September 23, 2002
IPN-02-076

SUBJECT: Indian Point Nuclear Generating Unit No. 3
Docket No. 50-286
**Response to Request for Additional Information Regarding
Relief Requests for the Third 10-Year Inservice Inspection Program Plan**

**Response to Request for Additional Information Regarding
Relief Requests for Third 10-Year Inservice Inspection Interval Program
Indian Point Nuclear Generating Unit No. 3 (IP3)**

**THIRD TEN-YEAR INSERVICE INSPECTION
INTERVAL PROGRAM PLAN
REVISED RELIEF REQUESTS**

ENERGY NUCLEAR NORTHEAST INDIAN POINT UNIT NO. 3	
PRESSURIZER RCPCPRI	
INT-1-2100	REV. 8

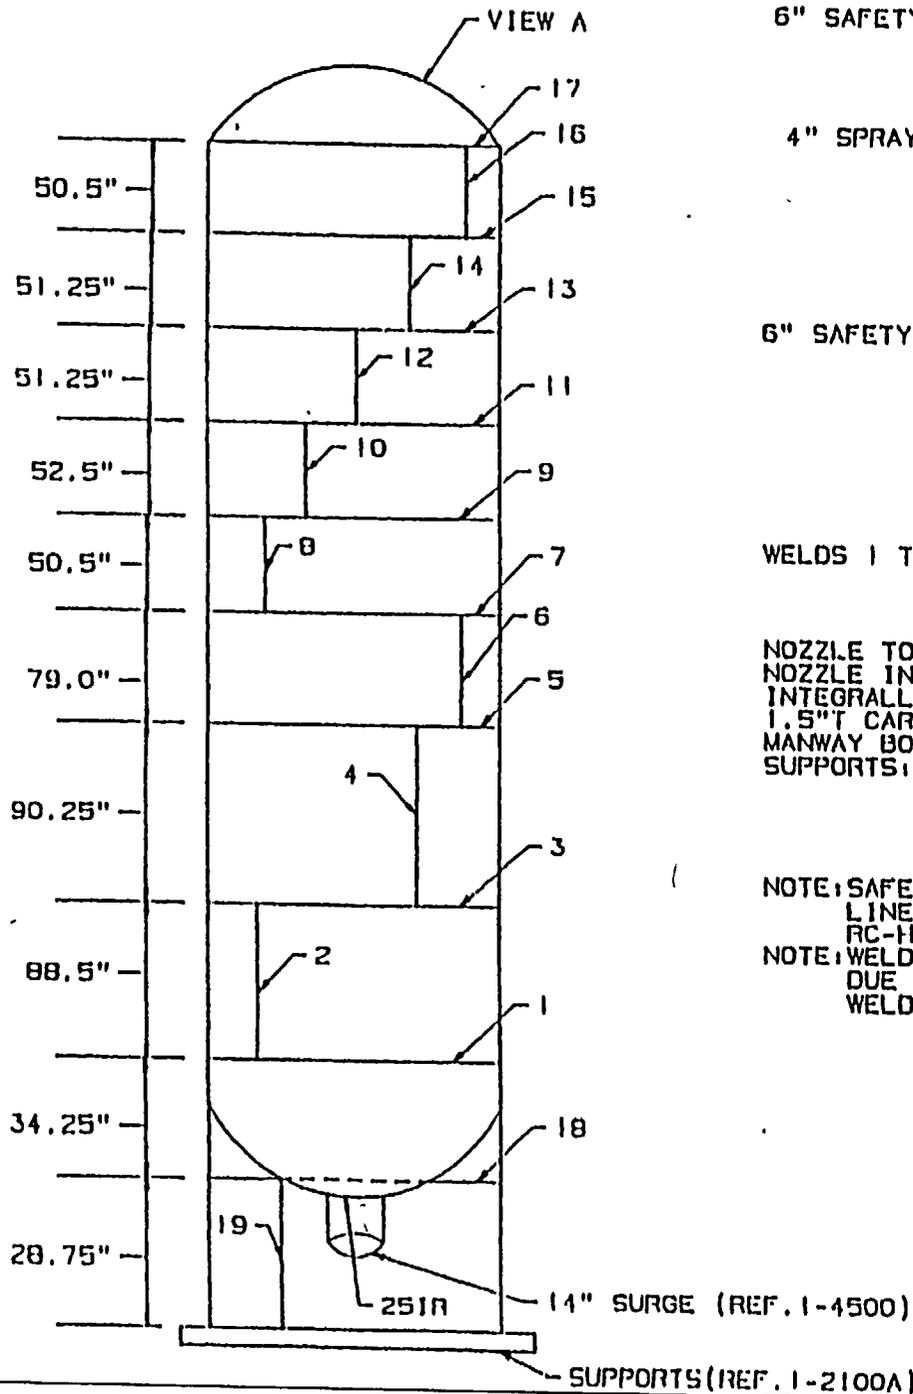
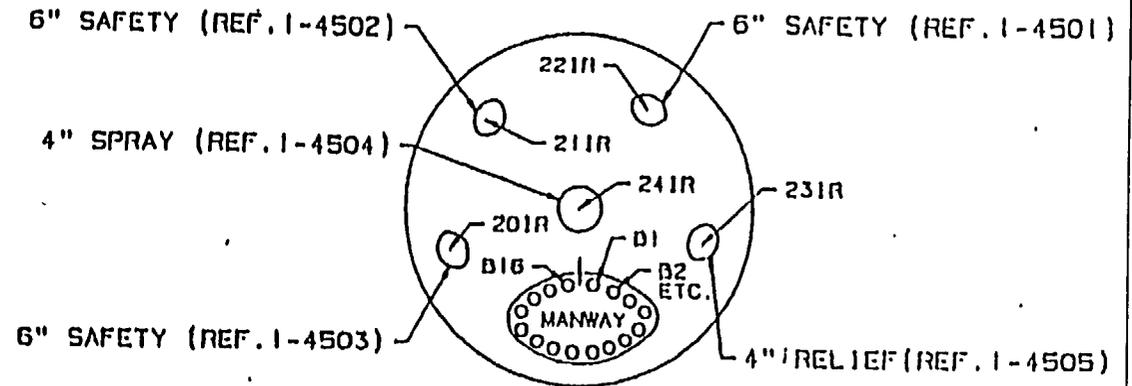
In addition, it appears that, for pressurizer bottom head Weld Number 1, greater than 90% volumetric examination is being obtained. Is the licensee using NRC-approved Code Case N-460? If so, no relief for weld number 1 is required. For Weld Number 2, confirm whether the insulation in place is permanently installed and whether the “access window” can be adjusted to allow inspection of the circumferential-to-longitudinal intersection of Welds 1 and 2. For Weld Numbers 16 and 17, confirm that no access is available for volumetric examination.

Indian Point 3 requests relief from performing the code required volumetric examination of the pressurizer upper head circumferential weld # 17 on sketch INT-1-2100 (attached) and from examining the intersecting one foot of the longitudinal shell-to-head welds (#s 2 and 16).

While the insulation drawing indicates that the insulation in the area of circumferential weld #17 is removable, the pressurizer safety relief piping and the proximity to the missile shield makes removal of the insulation and inspection of the weld impractical. The longitudinal weld #16 is just below weld #17 and is even more restricted by the missile shield.

The nozzles on the pressurizer are cast with the vessel heads. The identification numbers for these nozzles are 20IR, 21IR, 22IR, 23IR, 24IR, and 25IR as shown on sketch INT-1-2100. The as-cast surface of the heads, combined with the geometry of this area, makes ultrasonic examination of the nozzle inner radii impractical (see drawing 681J281). Entergy has consulted with EPRI on other inspection techniques, such as the phased array. Although phased array could cover a larger inspection volume, it is also limited by the requirement of a relatively smooth inspection surface. Because of the casting, the pressurizer nozzle surface is quite uneven and therefore not suitable for either the UT or the phased array inspection techniques. An uneven surface will change the direction of the beam, resulting in an amplified deviation. Additionally, to perform an effective inspection, a transducer matching the curvature of the nozzle area is also required. The varying curvature of the nozzles thus prevents an effective inspection of this area as well. The geometry and size of the nozzles are such that a radiographic examination is not feasible. Specifically, the radiographic test film cannot be placed properly from the I.D. due to a lack of interior structure. Placement of the source will not allow proper film to source distance, resulting in greatly reduced sharpness. Access to the exterior nozzle inspection area is also

Relief Request RR 3-14 is being resubmitted (Attachment 2), for welds nos. 2, 16 and 17 based on the impracticality of performing the examinations due to accessibility limitations, in accordance with 10 CFR 50.55a(g)(5)(iii). Relief for weld no. 1 is no longer required. Additional information on access limitation as requested is included in the revised relief request.

Visual examination (VT-2) will be performed of the upper head welds (#s 16 and 17) for evidence of leakage during system pressure tests in accordance with IWB-2500, Category B-P, and Code Case N-498-1. It is expected that any through wall defects would be detected by this examination prior to the failure of the pressurizer based on the expectation that the component will experience leakage before a catastrophic failure ("leak before break"). A similar request for relief was approved in the Second 10-Year interval (Reference SER dated November 7, 1991, TAC NO. 72247).

Volumetric examination of the lower longitudinal welds (#2) will be performed, but only to the extent practical as indicated above in this relief request. In lieu of the adjoining one foot of weld #2, an accessible foot of the weld will be examined to the extent practical.

In lieu of the code-required volumetric examination, all nozzles (with the exception of Pressurizer Surge Nozzle 25IR) will be examined visually (VT-3) using a remote color video camera. This visual (VT-3) examination for all accessible nozzles will be performed at the same time during an outage when the Pressurizer manway cover is removed for maintenance activities: or by the end of the 10-Year interval for ISI inspection. In addition, all nozzles will be visually examined (VT-2) at each refueling outage during system pressure tests in accordance with IWB-2500, Category B-P, and Code Case N-498-1. It is expected that any through wall defects would be detected by the proposed alternate examinations prior to failure of the component. This is based on the expectation that the component will experience leakage before a catastrophic failure ("leak before break")

LIMITATION TO EXAMINATION

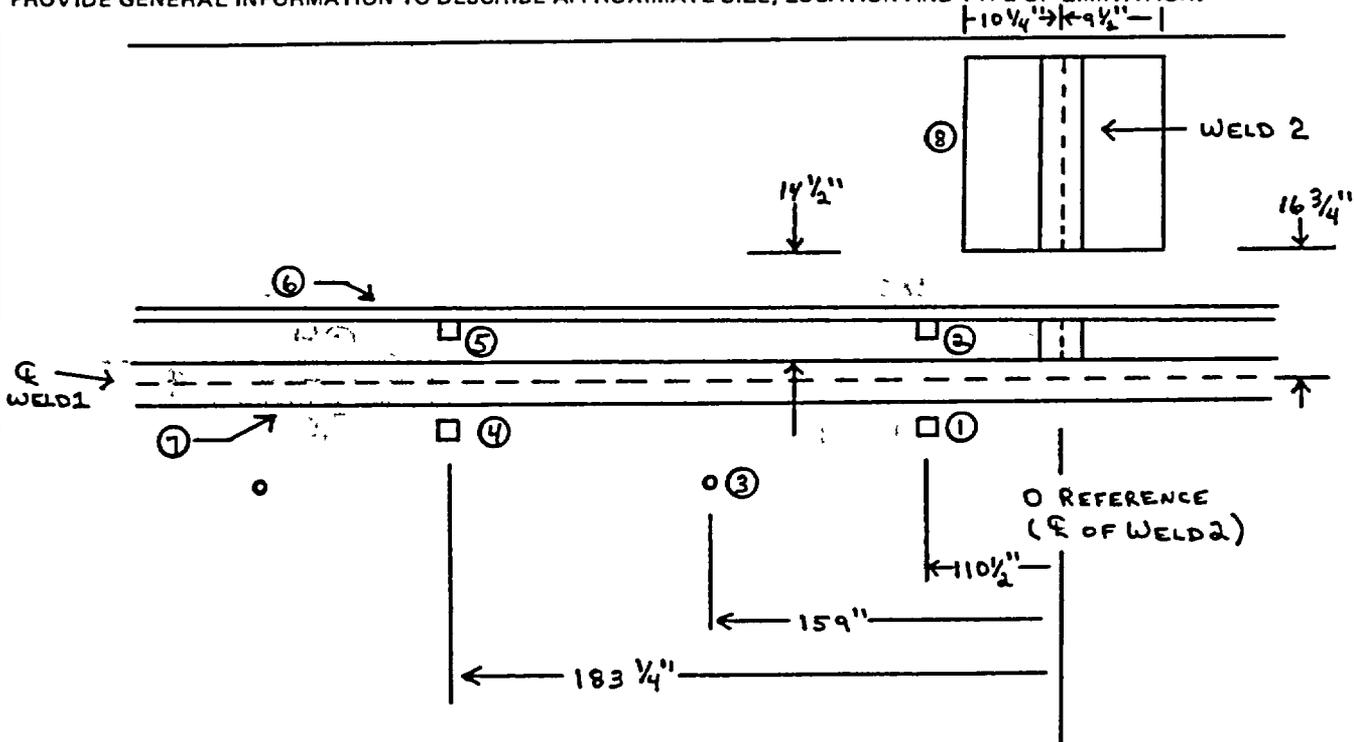
Longitudinal Weld #2 for the lower head had been examined in the past, but the required coverage could not be achieved due to access limitations. A similar relief was granted for the second 10-Year interval (reference SER dated November 7, 1991, TAC No. 72247). The first 15" of the section of the weld adjoining circumferential weld #1 is covered by permanent insulation. One foot of the weld above the first 15" was scanned in the last interval through an "access window" section of removable insulation, but the insulation near the weld limits the 45-degree and 60-degree scans as indicated in the attached "Limitation to Examination" sheets. The access window cannot be adjusted to increase the inspection area.

- ① 2"x2" WELDED PAD 3" FROM WELD & LIMITS 0°, 45°+60° 2, 7+8 SCANS
- ② 2"x2" WELDED PAD 3" FROM WELD & LIMITS 0°, 45°+60° 5, 7+8 SCANS
- ③ 1" INSTRUMENTATION LINE 6 1/2" FROM WELD & LIMITS 45°+60° 2 SCAN
- ④ 2"x2" WELDED PAD 3" FROM WELD & LIMITS 0°, 45°+60° 2, 7+8 SCANS
- ⑤ 2"x2" WELDED PAD 2 3/4" FROM WELD & LIMITS 0°, 45°+60° 5, 7+8 SCANS
- ⑥ INSULATION SUPPORT RING 4 1/2" FROM WELD & LIMITS 0°, 45°+60° 5, 7+8 SCANS
- ⑦ WELD CROWN LIMITS 0°, 45°+60° 2, 5, 7+8 SCANS
- ⑧ PERMANENT INSULATION LIMITS 45°+60° 2+5 SCANS
